Sunroof Water Leak Bulletin

1984-86 FIERO (WITH AD3) Conditions, which contribute to water leaks on 1984 to 1986 Fiero sunroofs, can be repaired by adding drainage holes to the plastic roof outer panel and replacement of hardware nuts at the hinge and latch locations on the glass panel.

(Figure 3 - Sealing Location)

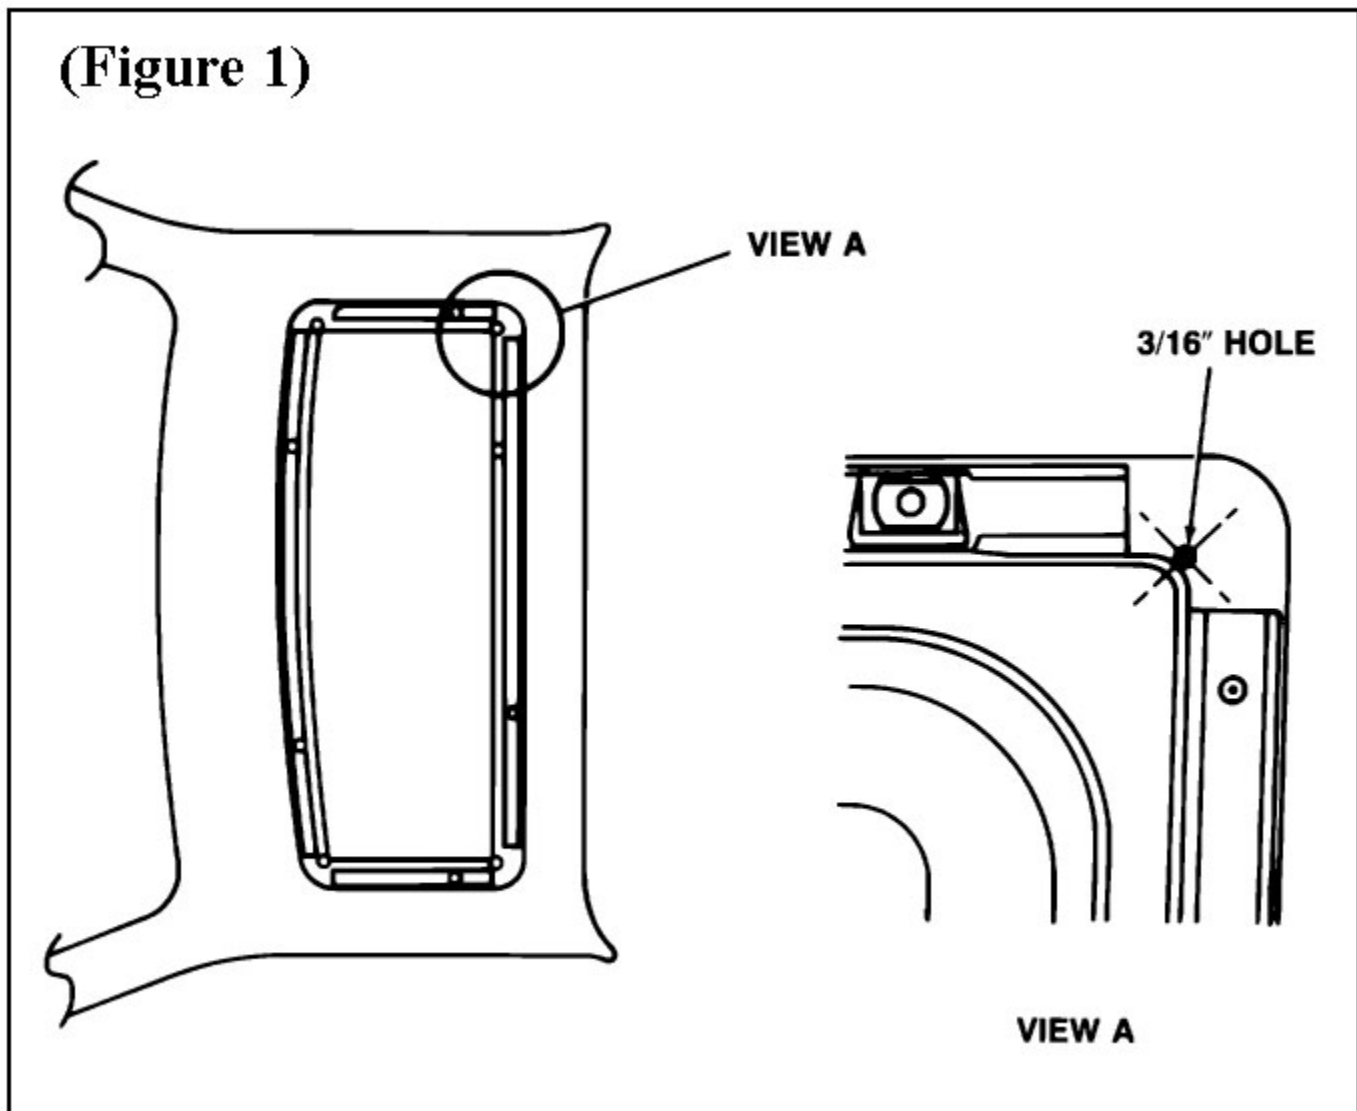
If the sunroof opening weatherstrip is damaged and requires replacement, it is important that the weatherstrip be properly installed and sealed to the tracks and body panels.

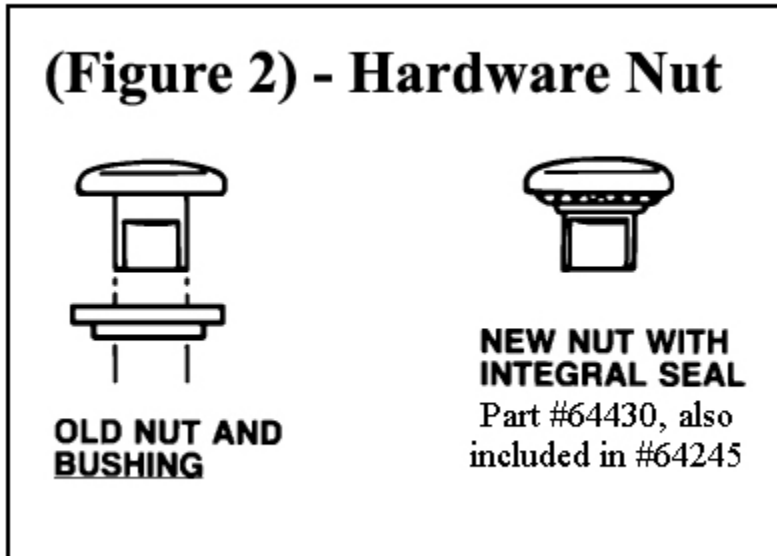
The addition of holes provides a water drain system and are to be drilled through the Plastic Roof Outer Panel Only. The holes are to be located in all four (4) corners of the weatherstrip mounting area. Figure 1 shows the location of the holes with the weatherstrip removed for illustrative purposes.

2. During the following drilling operations, it will be necessary to hold the weatherstrip out of the way to prevent damage. Using a drill and 3/16" drill bit, drill one hole (through the plastic roof outer panel only) in each corner of the weatherstrip cavity as shown above in Figure 1, view A.
